CERTIFICATE OF APPROPRIATENESS

Proposal: New Construction: Single-Family Residential

ITEM E4

September 8, 2022 HPO File No. 2022_0173 1429 Columbia St Houston Heights East

Side Setbacks (Addition and New Construction)

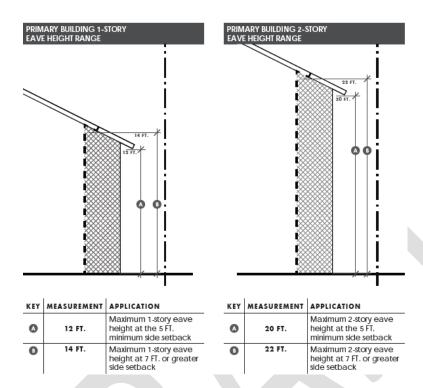
Proposed North side setback (1): 13'

Proposed South side setback (2): 5

Cumulative side setback: 18'

Front Wall Width and Insets (New Construction)

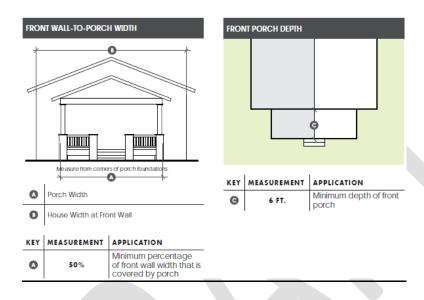
Proposed front wall width: 26' (Max. width of 2-story building for lots less than 50' wide is 35' wide. This lot is 44' wide.
